White Farm Equipment Company

Service Bulletin

Location: Charles City
Subject: 1255, 1265, 1355, 1365
Transmission Seizure
Number: 430 594
Date: 10-16-73
File: C Transmission
1 of 2

Old and New Transmission Parts

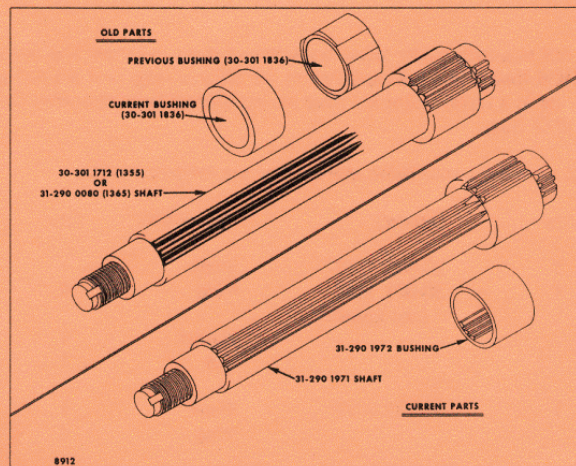
Possible transmission inner ring (Bushing) seizure on some 1255, 1265, 1355 and 1365 tractors.

Bushing may seize in driven gear. Seized bushings may rotate on lower transmission shaft resulting in failure of shaft.

1265 and 1365 production models are now equipped with inner rings splined directly to driven shaft to prevent rotation on shaft. Bushings are phosphate coated to prevent seizing in driven gear.

Repair bushings for tractors not requiring a new lower transmission shaft are phosphate coated and do not have four flat areas machined on them.

If problem exists purchase and install 31-290 1988 Phosphate Coated Inner Rings.

If problem exists on tractors not requiring a new lower transmission shaft, purchase and install 30-301 1836 Phosphate Coated Inner Rings. 30-301 1836 Inner Ring is a replacement for original rings that are not splined to driven shaft. Do not use 30-301 1836 Inner Ring as a replacement for rings having splined inner diameter. Original rings having splined inner diameter order 31-290 1972 Ring.
